SEWAGE DISPOSAL SYSTEM

DEPARTMENT OF HEALTH AND MENTAL HYGIENE

SUBDIVISION Flamewood LOT 10, Blk. B ROAD 7469 Flamewood Drive

REPAIR - PURPOSE - DRYWELL FAILED

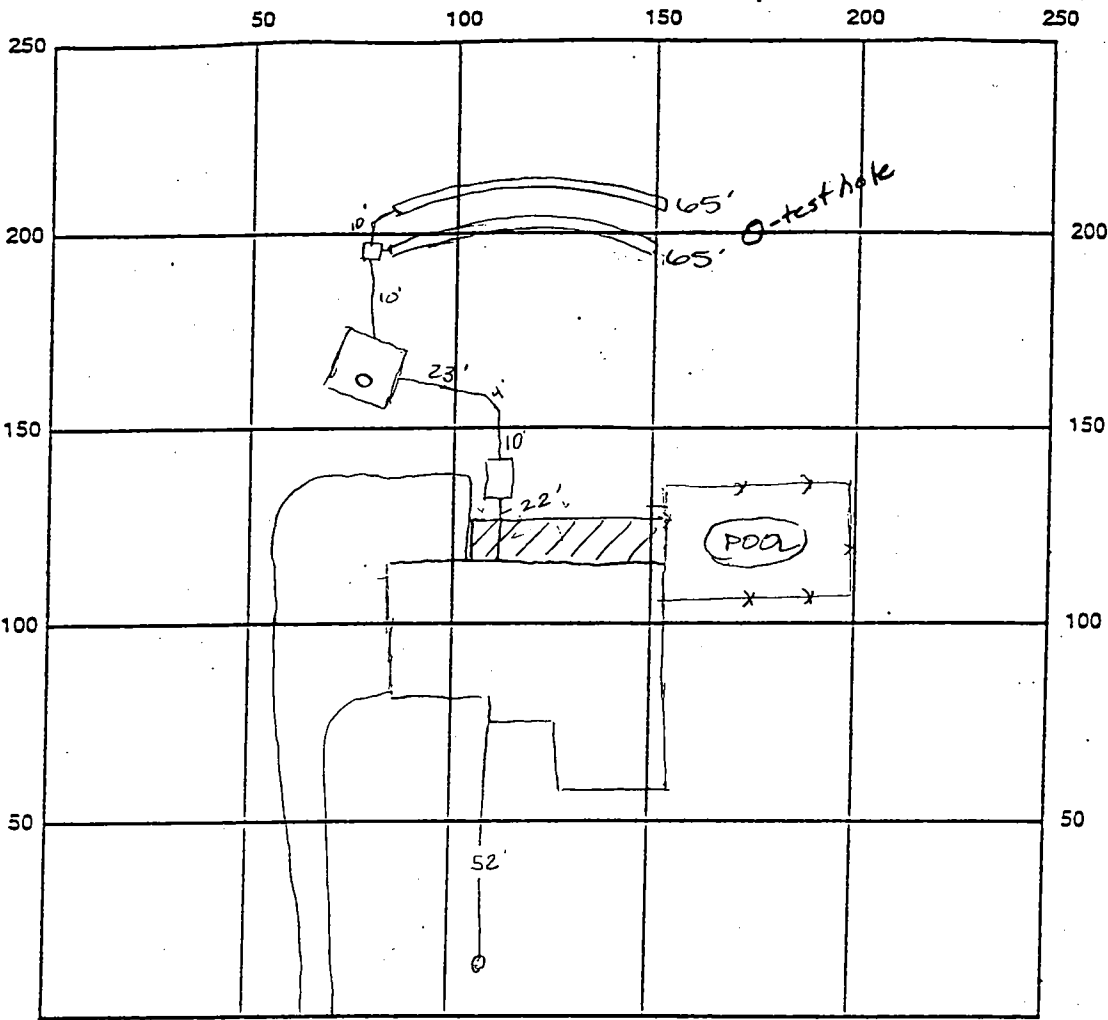
REMARKS: 1/12/99 Well tag unreadable - Install 2 trenches - max 9' bottom at high end, max 6' bottom at low end - trenches not on contour but are level - OK to cover all work

PERMIT CARD *Old Sept. final*

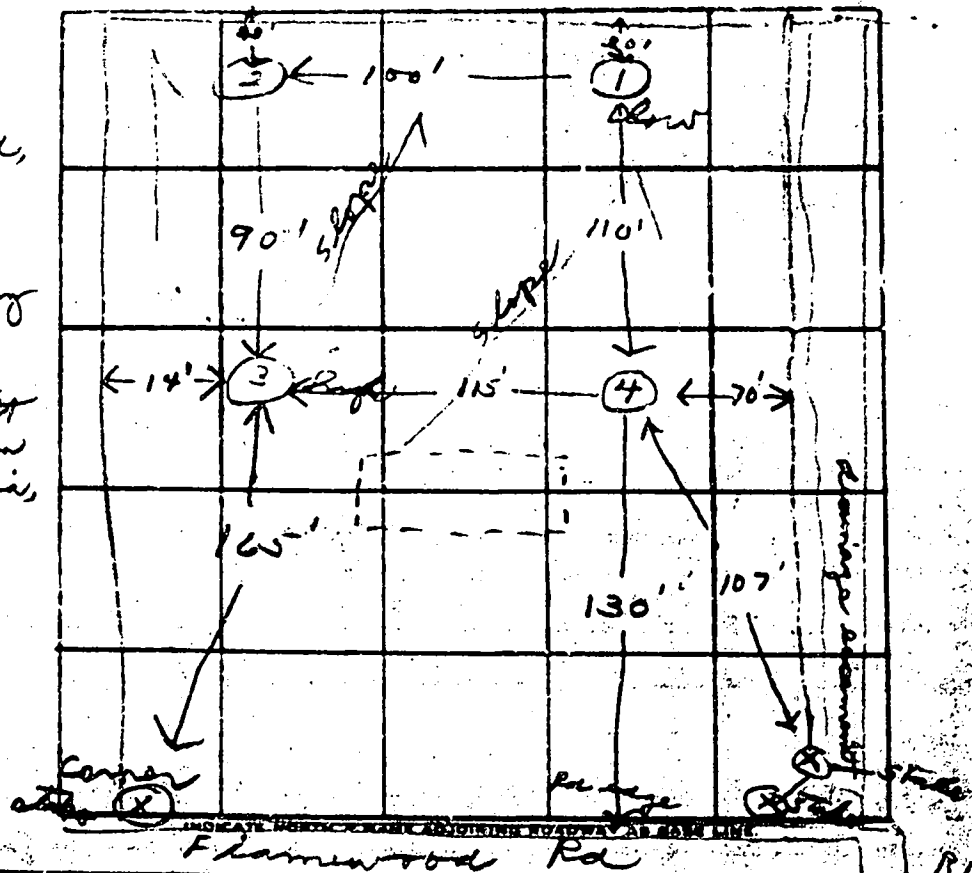
REMARKS 5/6/81 Cap required on drywell cleanout standard F.S.

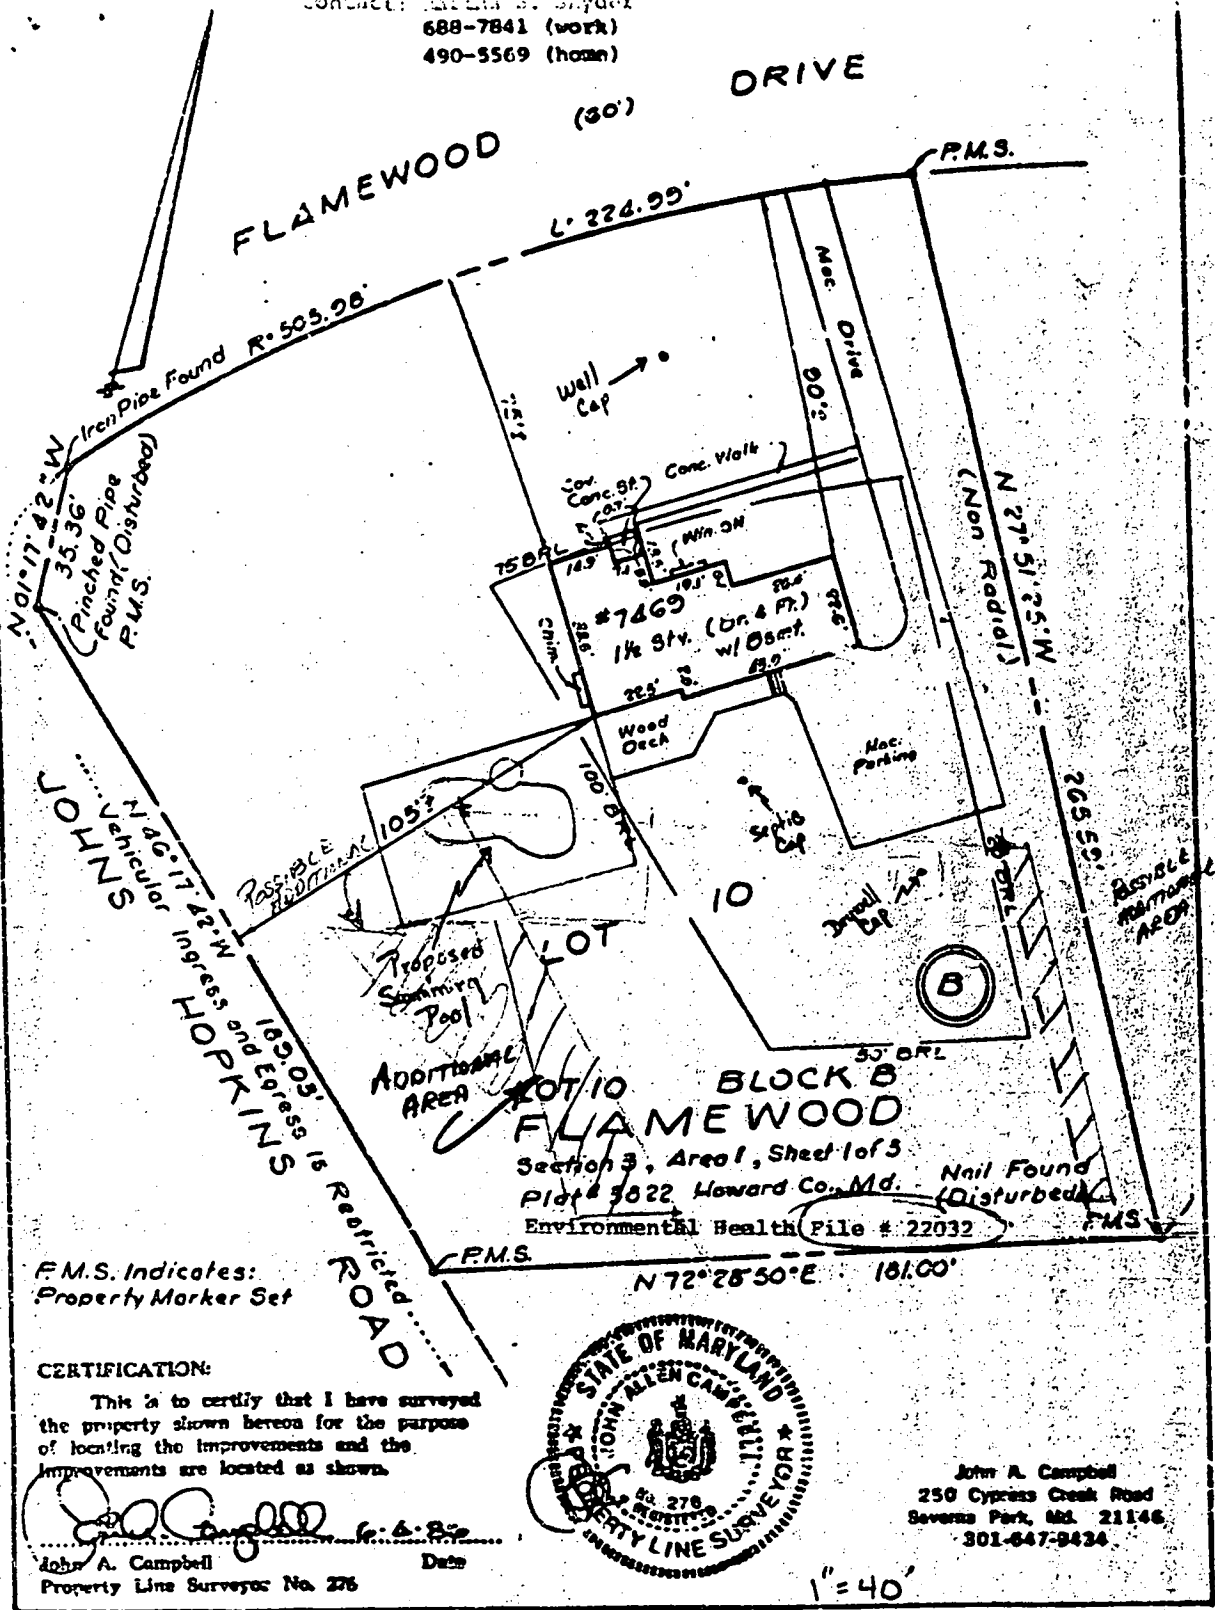
5-24-95
Proposed replacement
of existing wood
deck will have no
impact to existing well
or septic. OK to
proceed. Amy
McMullen
